CHAPEL HILL ADDITION
TO WICHITA, SEDGWICK COUNTY, KANSAS

RE: S/D 9884 - Final Plat of CHAPEL HILL ADDITION

RE: S/D 9884 - Final Plat of CHAPEL HILL ADDITION

CASE NUMBER: S/D 98-84 - CHAPEL HILL ADDITION

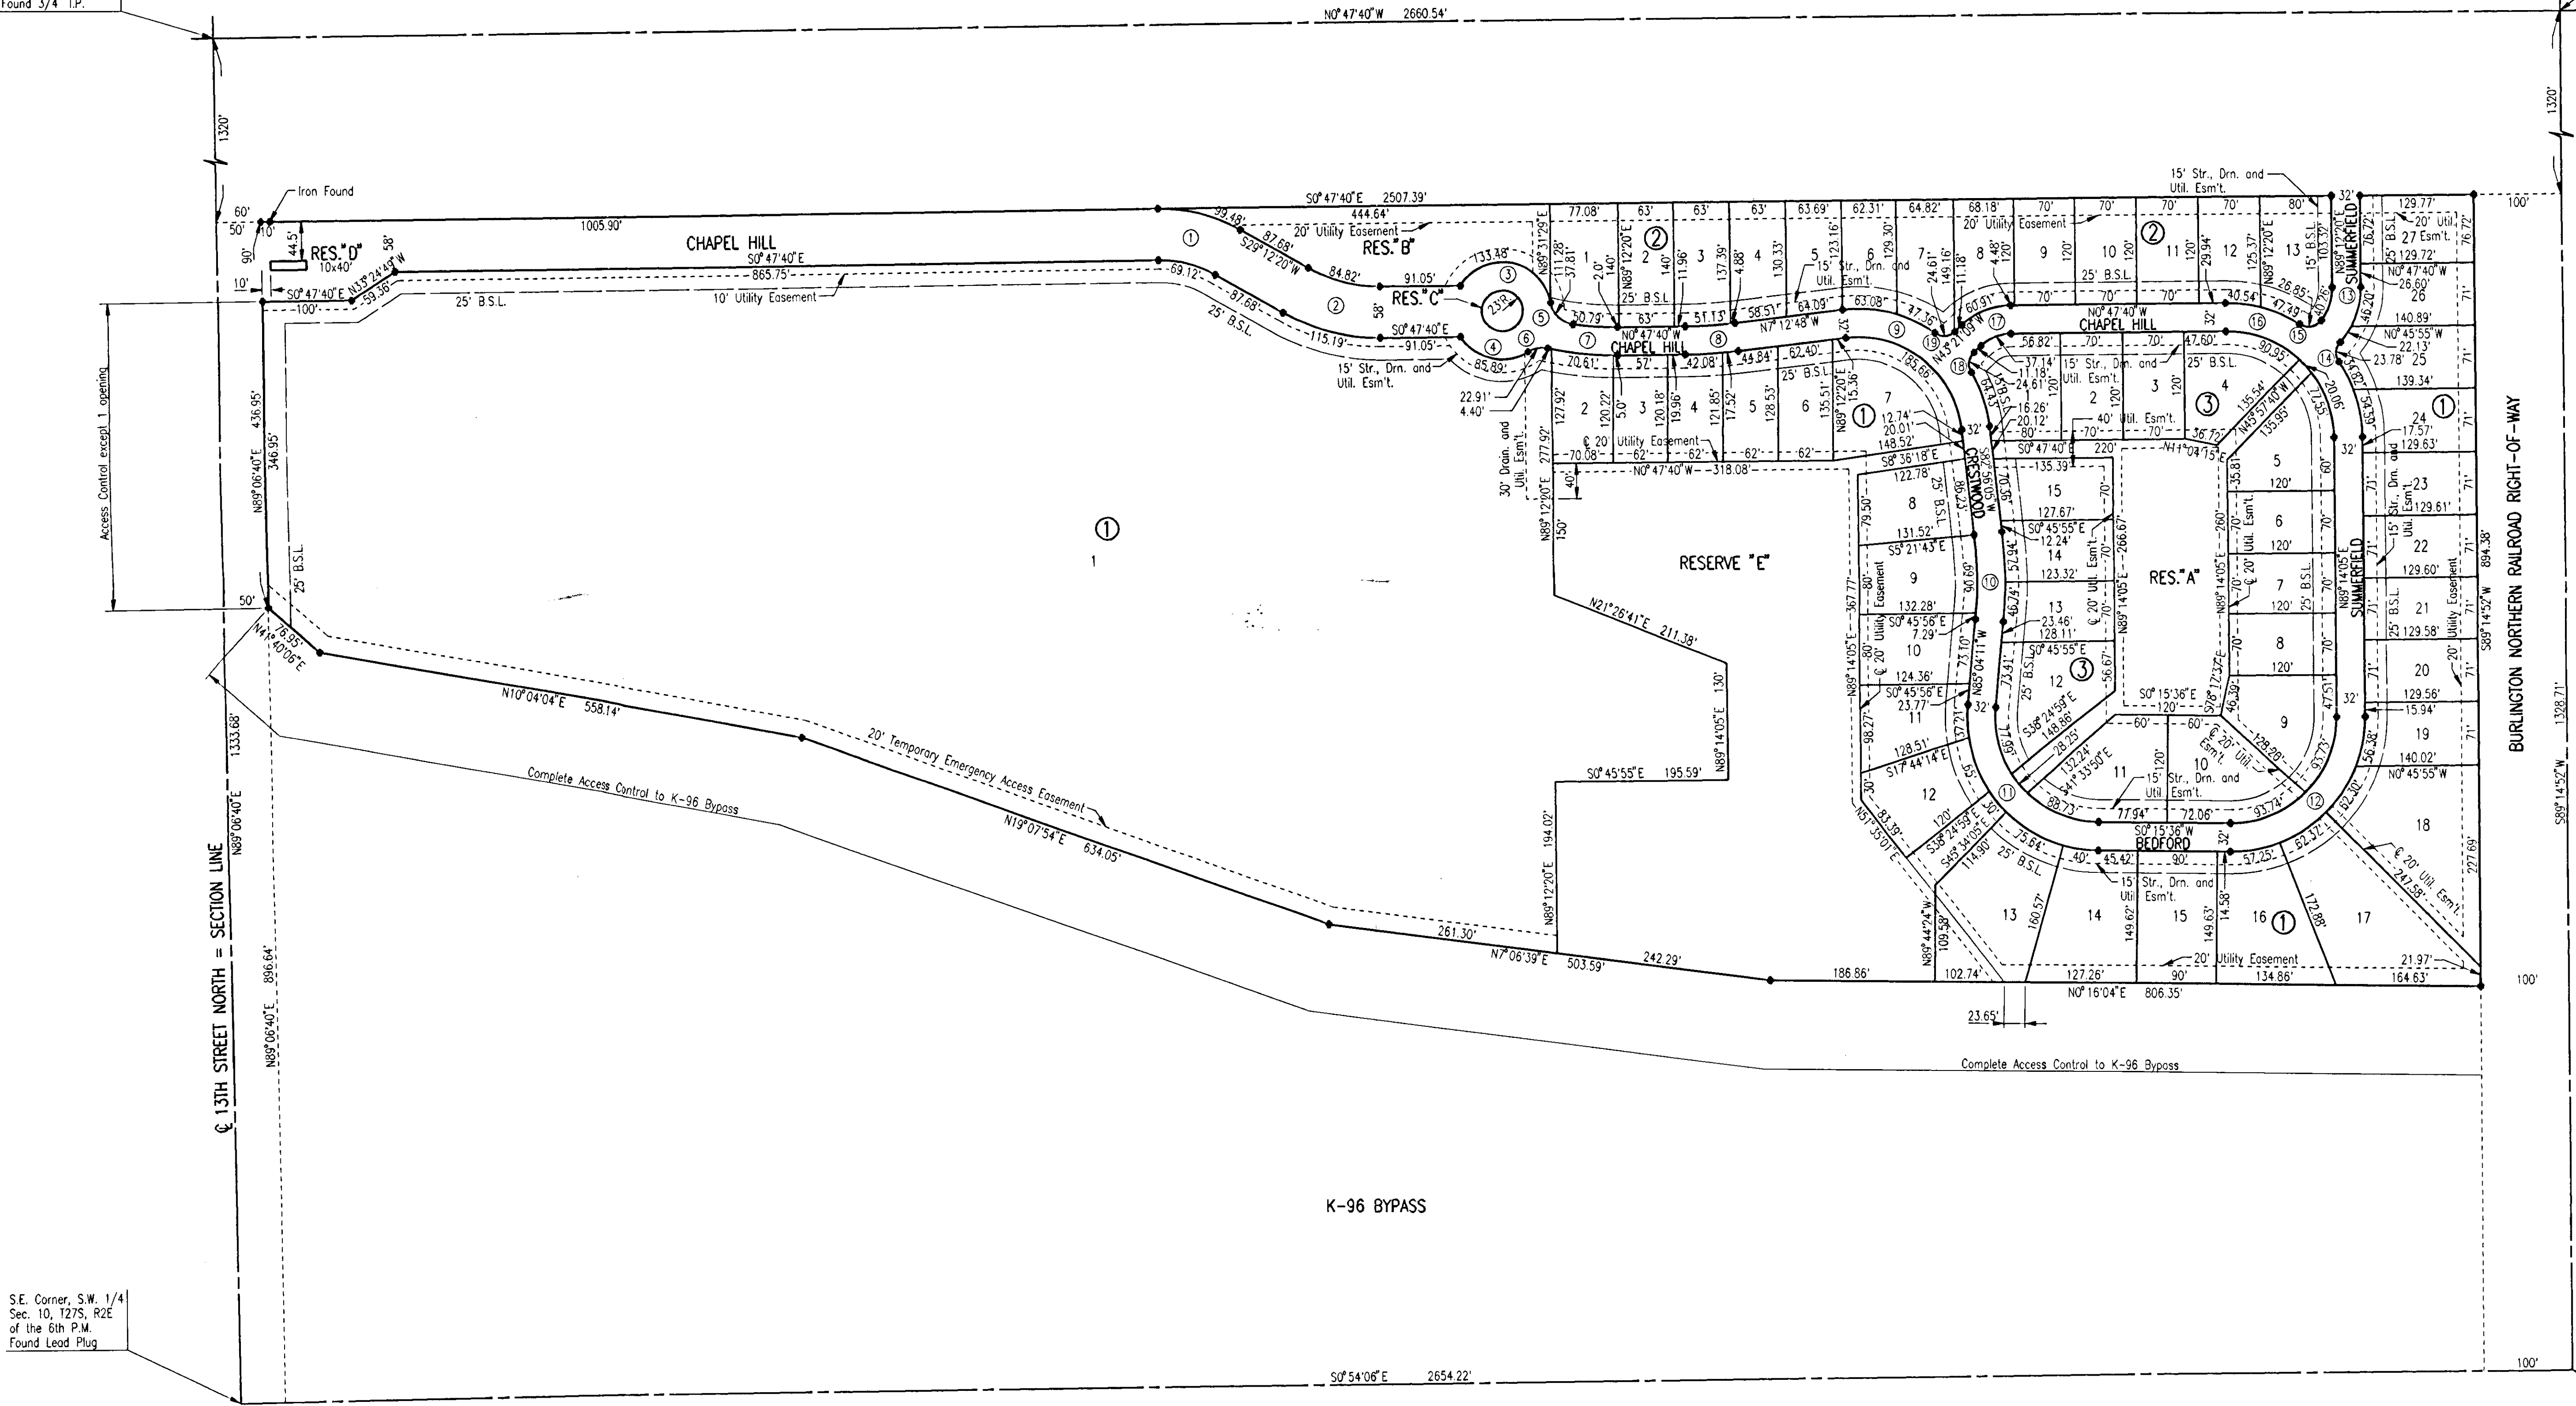
- E. **City Engineering** needs to comment on the status of the applicant's drainage concept and of any minimum building pad requirements as a result of a lake (Reserve E) being created. **A letter is needed from KDOT pertaining to their acceptance of drainage onto K-96. The drainage concept is approved. Minimum pad elevations need to be denoted for lots adjacent to the detention pond.**

The final plat has included the requested minimum building pad elevations. City Engineering needs to comment on the status of the applicant's drainage plan. The drainage plan is approved. A drainage guarantee is required.

- F. The plat denotes one access opening along 13th St. North. Traffic Engineering needs to comment on the need for complete access control on the east side of the frontage adjoining K-96. The plat's text on the final plat, shall note that access controls are being dedicated to the City of Wichita and that the location of the opening is subject to approval by the City Engineer. Access controls are sufficient.
- G. The distance to the northernmost lots is approximately 3,000 feet; in excess of the 600 foot maximum noted in the Subdivision Regulations for cul-de-sac access. Currently, the proposed street stub to the west does not have any connection and Fire Department needs to comment on a potential emergency access easement for a second point of access to this plat. City Fire Department requires a second point of access. Applicant has agreed to include an emergency access easement.

The final plat has included the requested emergency access easement; however it should be extended northward to connect with Crestwood Street.

- I. Since this plat proposes the platting of narrow street right-of-way with adjacent "15-foot street drainage and utility easements", a restrictive covenant shall be submitted which calls out restrictions for lot-owner use of these easements. Retaining walls and change of grade shall be prohibited within these easements as well as fences, earth berms and mass plantings.

- K. Traffic Engineering needs to comment on the need for improvements to 13th St. North. No improvements are needed.
- L. The applicant shall guarantee the paving of the proposed interior streets. For the narrow public 32-foot streets, this guarantee shall be for the 29-foot paving standard. This guarantee shall also provide for sidewalks along one side of the streets. The Applicant has submitted an alternate sidewalk plan. The plan denotes a sidewalk around the perimeter of the park (Reserve A) with connections along
